Ref:
SSD-82709458

RE: SUBMISSION TO SSD-82709458, Residential development with infill affordable housing
Address: 19-25 Balfour Street, Lindfield

Ku-ring-gai Council's objection to SSD- 82709458, 19-25 Balfour Street, Lindfield

Figure 1: Alternate TOD - Proposed zoning

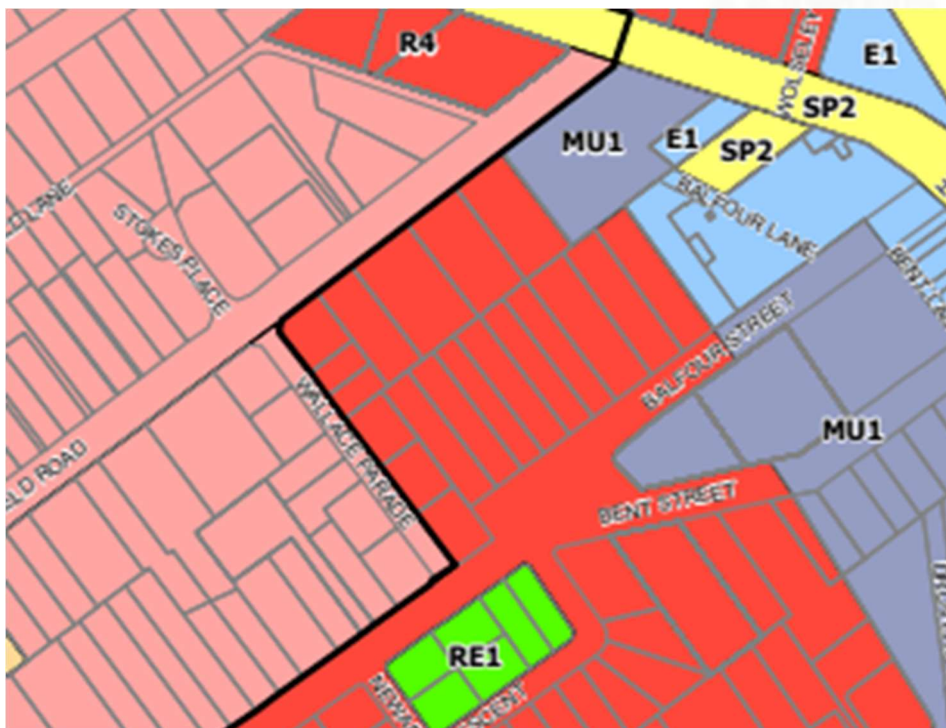
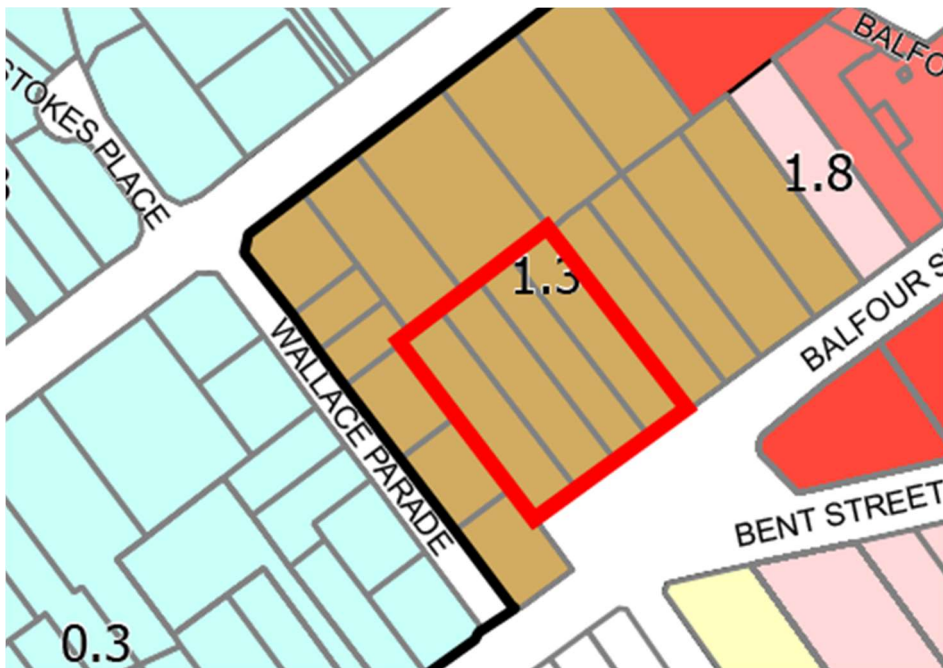
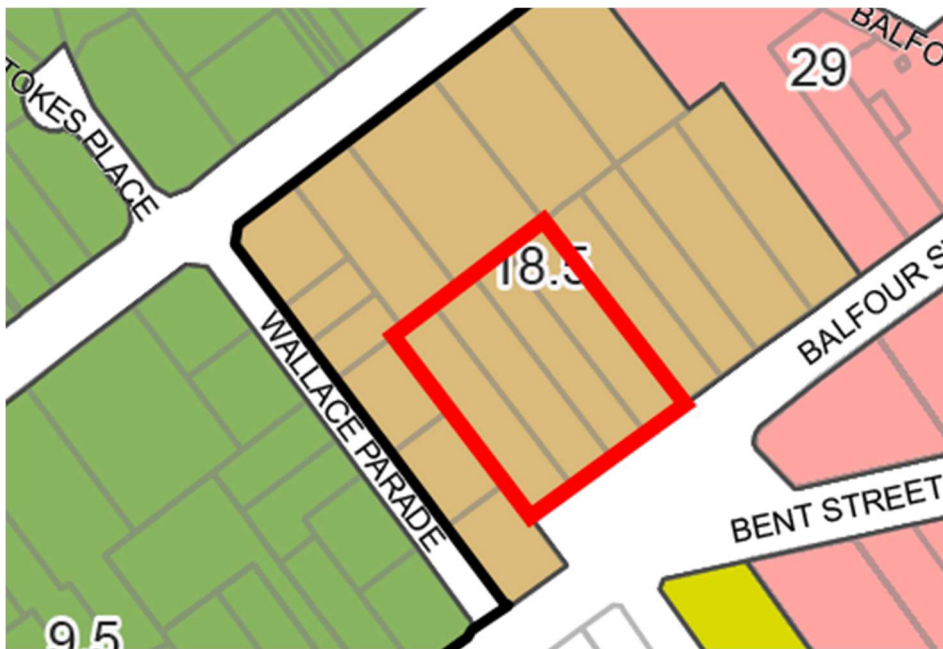
Figures 1-3 above show the location of the proposed development (red outline) in relation to Council's TOD Alternative Scenario. It is important to note that the TOD Alternative Scenario seeks to ensure an appropriate height and density transition between the Pacific Highway and railway corridor and the lower density residential properties to the west of Wallace Parade.

Ground Floor Communal Space as per Landscape Plan

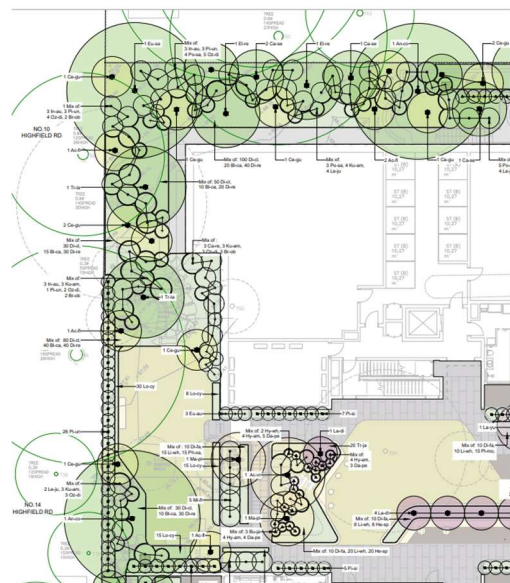
The design guidance also states that *“direct, equitable access should be co-located with deep soil areas.”* The primary communal open space on Level 1 does not comply with this principle. While it is nominally accessible from the Communal Courtyard below, it is exclusively overlooked by Unit 108, raising issues of equity, privacy and functionality. This design outcome risks reducing the sense of shared ownership and usability of the space, contrary to the ADG's intent for communal open space to be inclusive, equitable, and genuinely communal.

On this basis, the proposal does not meet the minimum quantitative requirement (25%) for communal open

space, nor does it comply with the qualitative design guidance relating to access and usability.

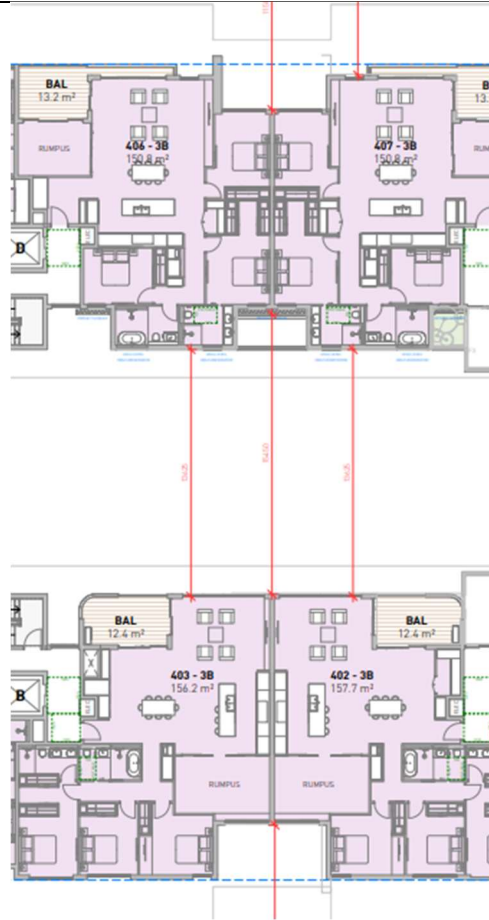
On levels 1-3, the balconies of units 101 and 103, 201 and 203, and 301 and 303 are offset very small distance (its not marked on the plan, but is estimated at approximately 4-5m, when balconies are supposed to be offset 12m.

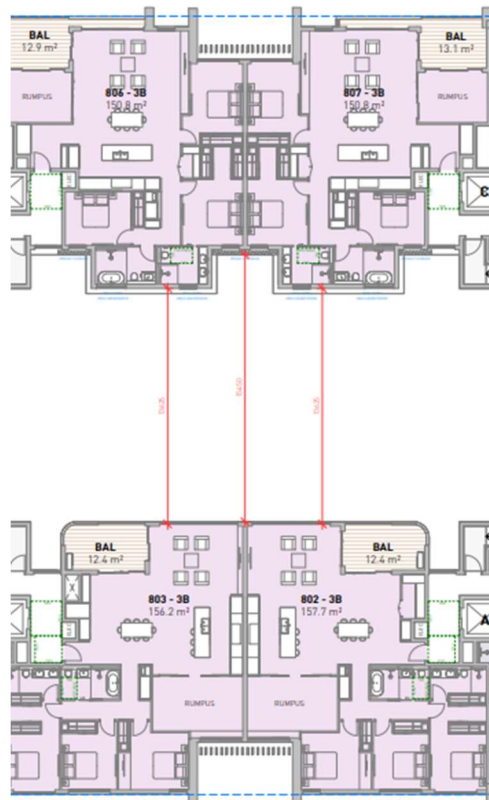
On levels 4-7 the separation distance between the living room windows 402, 403, 502, 503, 602, 603, 702 and 703 are offset only 15.45m from the bedroom windows 406, 407, 506, 507, 606, 607 and 706 and 707, when 18m is required.

Figure 4: extract height plane diagram

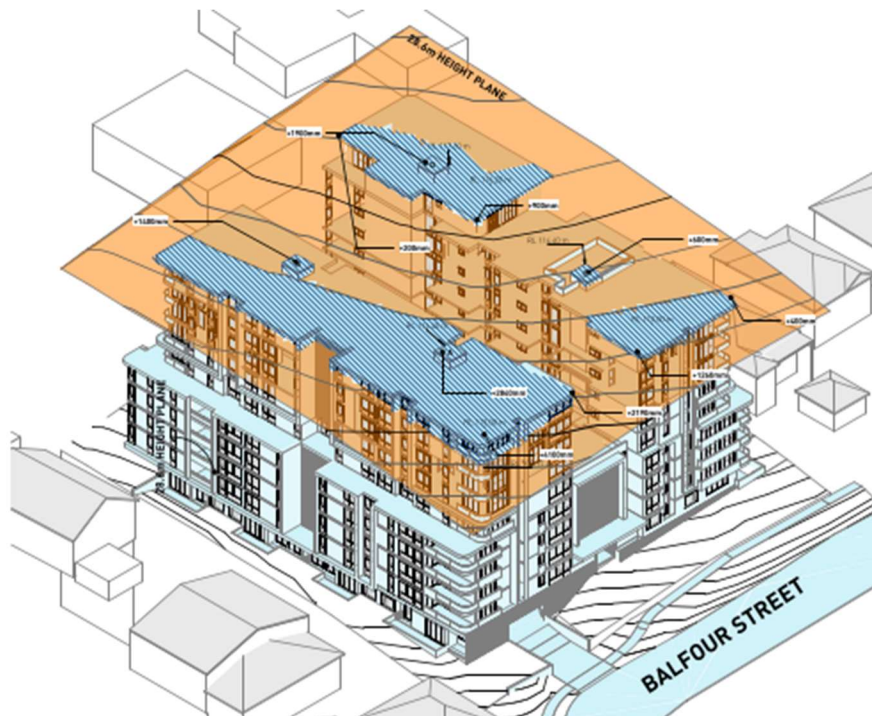
- The clause 4.6 variation states that the breaching elements collectively represent a minor portion of the building envelope. However as demonstrated in the height plane diagram more than 50% of the upper levels project above the allowable building height.

- It is disagreed that the breach is *marginal and that the environmental impacts as a result of this exceedance are minimal*. The proposed breach is up to 4.1m for an area of over approximately 50% of the upper level with resulting solar access and bulk and scale impacts to surrounding properties and the streetscape. Council also questions the accuracy of the submitted height blanket diagram (Figure 4 below) as it appears to be based on extrapolated ground levels (consistent with the approach taken in *Bettar*) as opposed to ground levels that exist on the site.

Proposed view towards Balfour Street

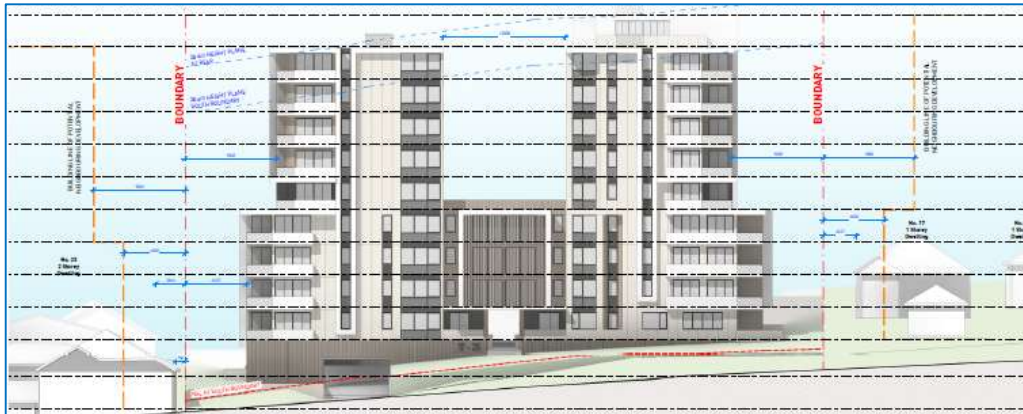
The site is also located in the vicinity of heritage items at 28 Bent Street and 6 Highfield Road. Views from the heritage items will be obscured by a large scaled residential flat building.

Unacceptable Site consolidation for new development within an HCA

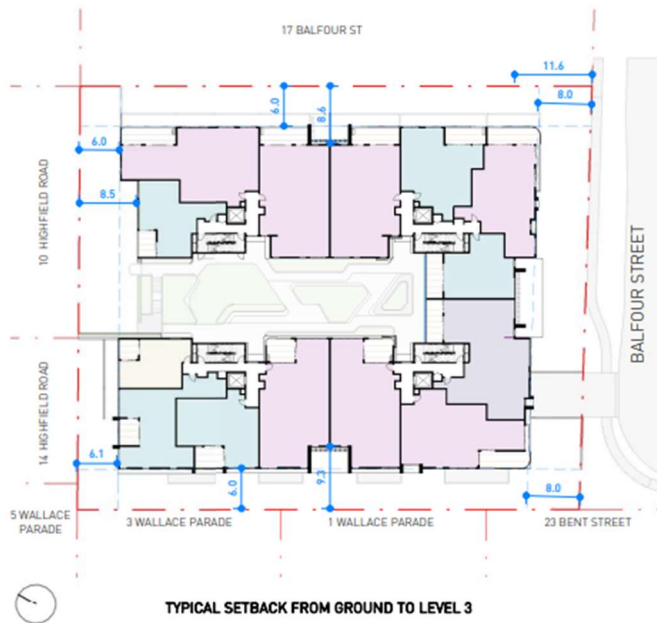
The proposal includes amalgamation of four properties, which demonstrate original DP 4195 subdivision pattern, and its re-subdivision for individual houses' development in the Federation / Interwar period. The resulting amalgamated allotment would not retain the typical block width characteristics and historic subdivision patterns of the area.

The proposed amalgamation is for purposes of constructing a multi-level building, conflicting with the scale of the houses in the Heritage Conservation Area which are predominantly single level. This will adversely impact the significance, character and appearance of the HCA.
